# CITY OF ALBUQUERQUE

**Re:    Mountain Mahogany Community School PH II, 5014 4<sup>th</sup> St NW,  
Request for Permanent C.O. –Accepted  
Engineer's Stamp dated: 03-01-12, (F14/D062)  
Certification dated: 07-12-12**

**Re: Mountain Mahogany Community School, 5014 4<sup>th</sup> Street NW**  
**Grading and Drainage Plan**  
**Engineer's Stamp date 3-01-12 (F14/D062)**

**Re: Mountain Mahogany Community School, 5014 4<sup>th</sup> Street NW, Grading and Drainage Plan**

ISAACSON & ARFMAN, P.A.  
Consulting Engineering Associates  
Albuquerque, New Mexico  
1805 C-701-LAND AREA 07.2012

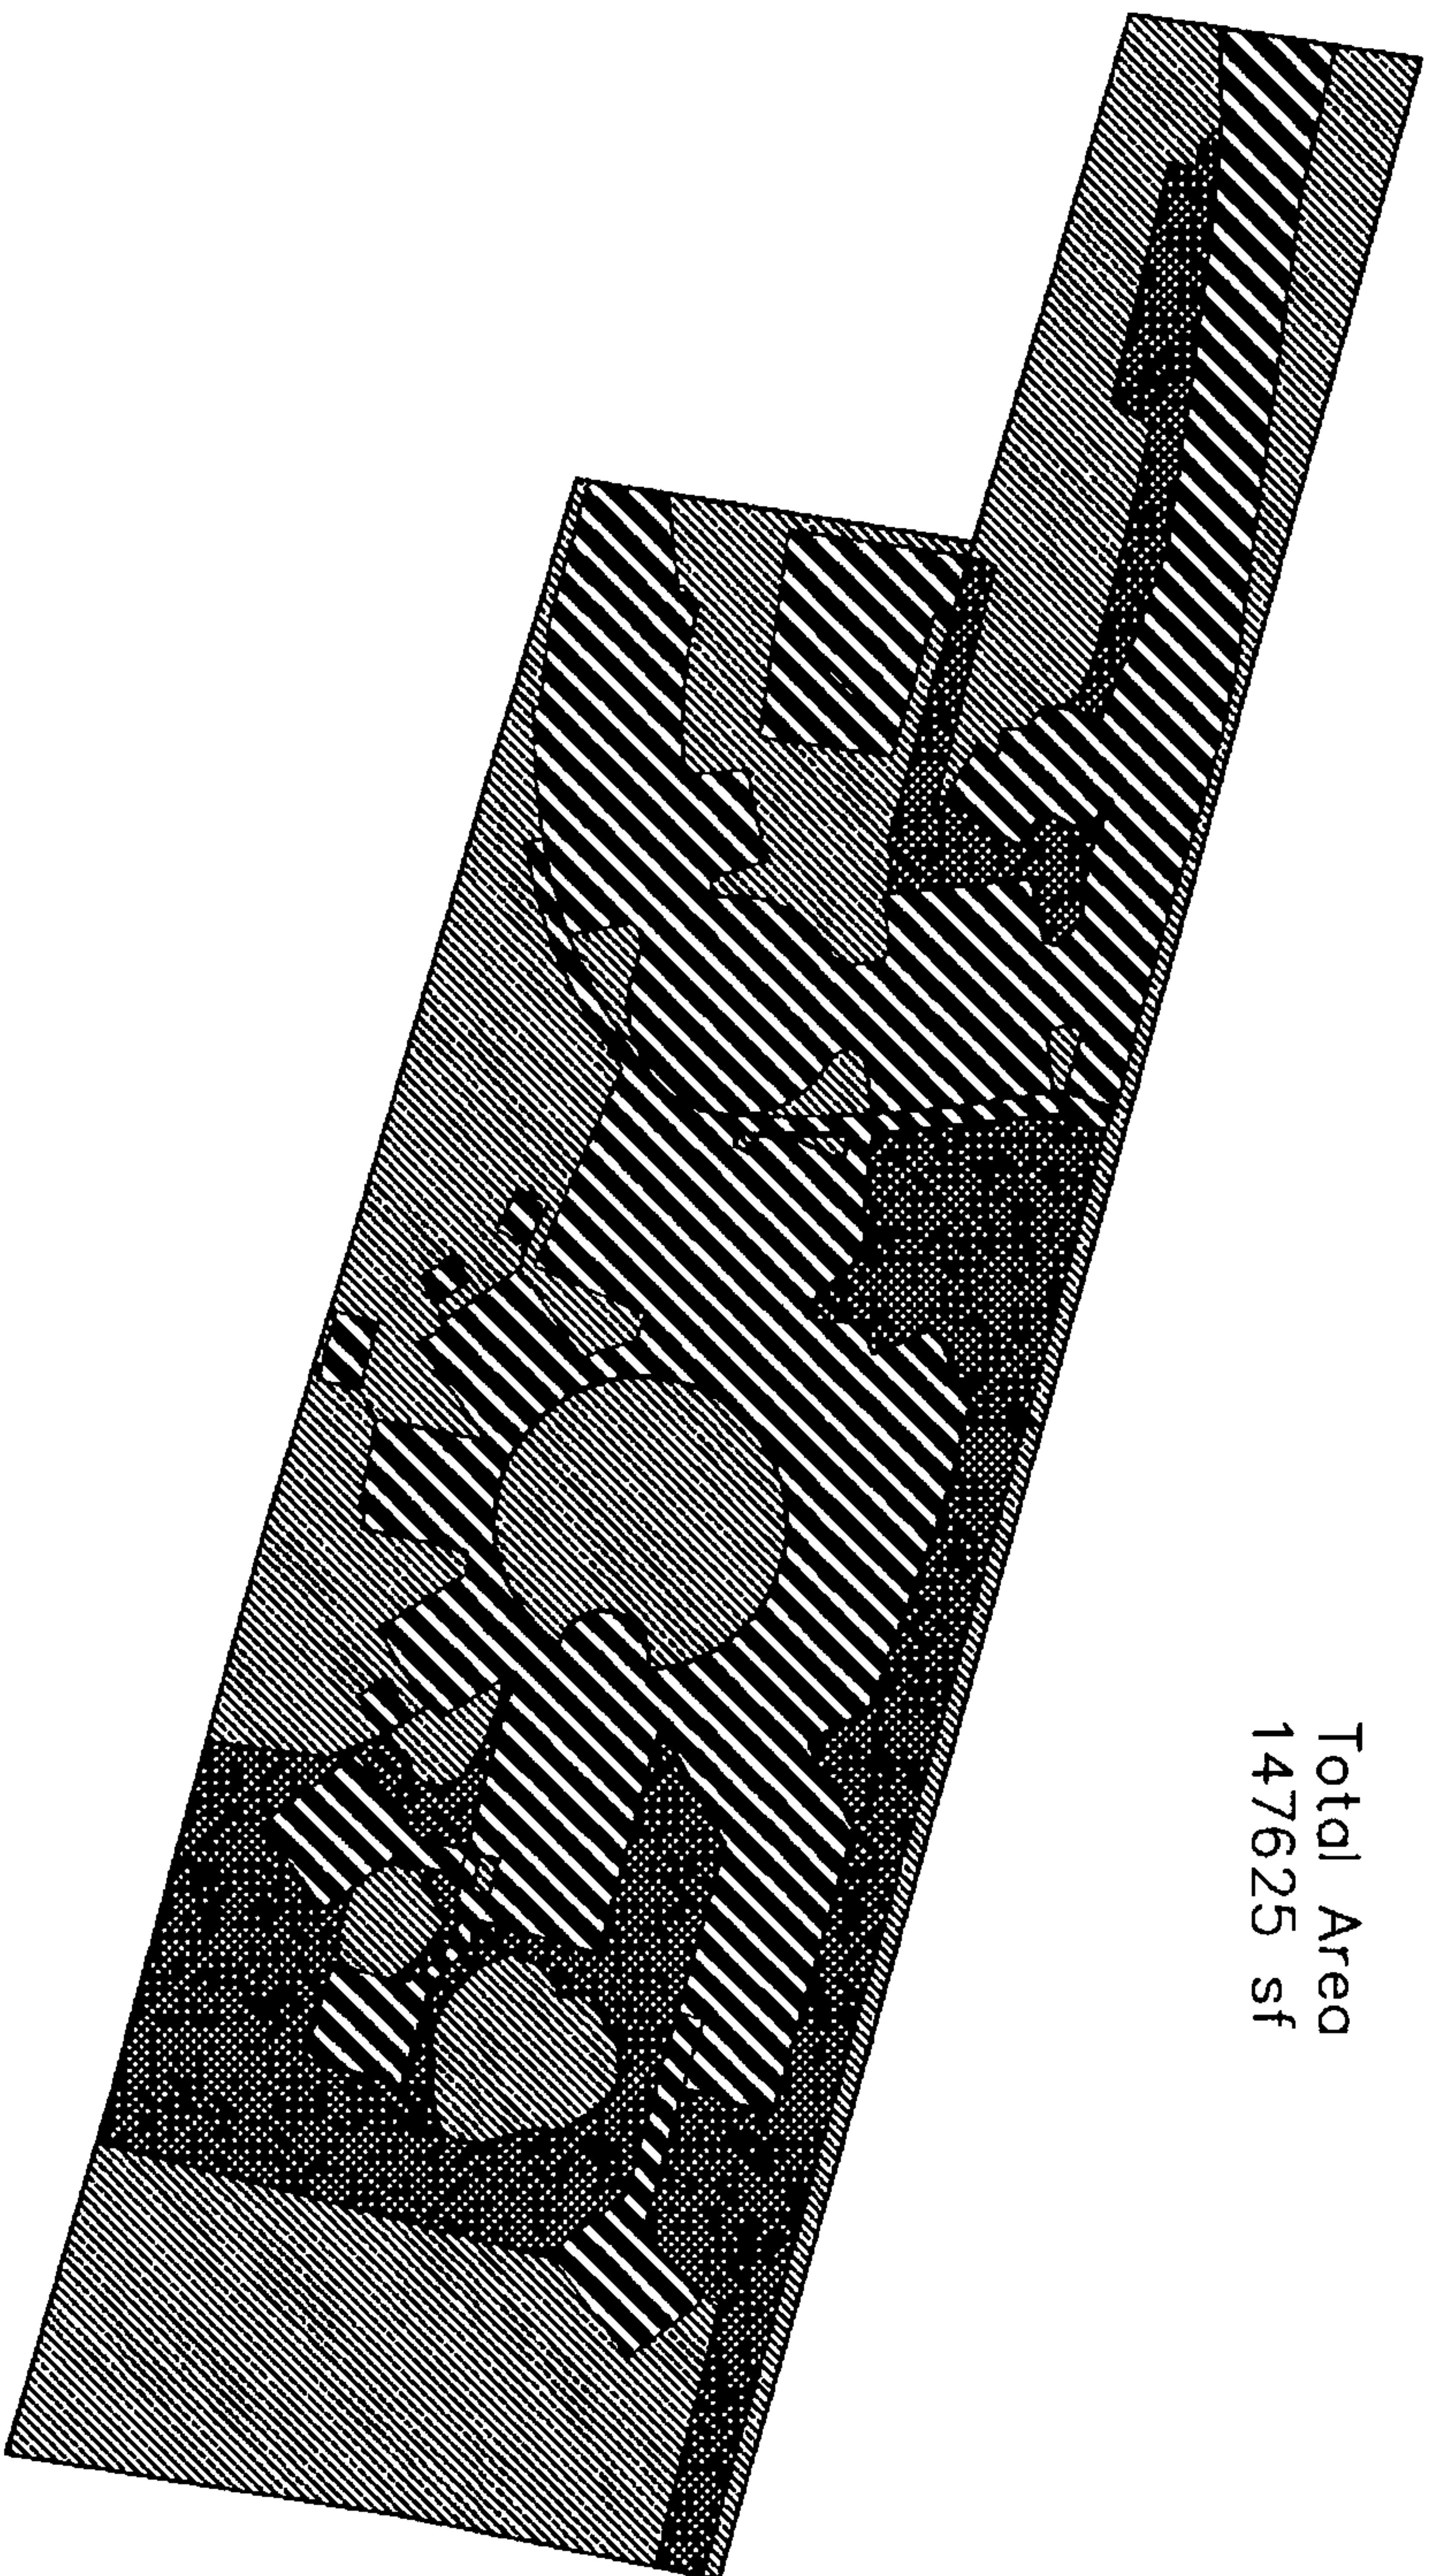
- An approved Grading and Drainage plan is on file for this property and the proposed grading appears to impact the on-site retention ponds that were approved to contain the 100 yr, 10 day storm event.
- One of the existing structures was previously built without a permit and encroaches on one of the approved retention ponds.
- The proposed structures also appear to encroach on another on-site retention pond.
- Provide pond volume calculations to ensure proper water retention is maintained.

1. A pond volume analysis is included in the supplemental information to address the proposed construction as well as to provide for some additional future improvements.
2. We have called for the installation of six percolation pits within the various ponds to assist with draining the ponds. There is a shallow clay lens (within the upper 4 feet).

In order to generate the volumes required for each of the conditions, land treatment areas were calculated (see Land Treatment Maps) and the resulting percentages were entered into the DPM calculations to obtain the volume generated for the 100-year 6-hour storm event. The 100-year 10-day volume was then calculated per the DPM to determine the required ponding volume.
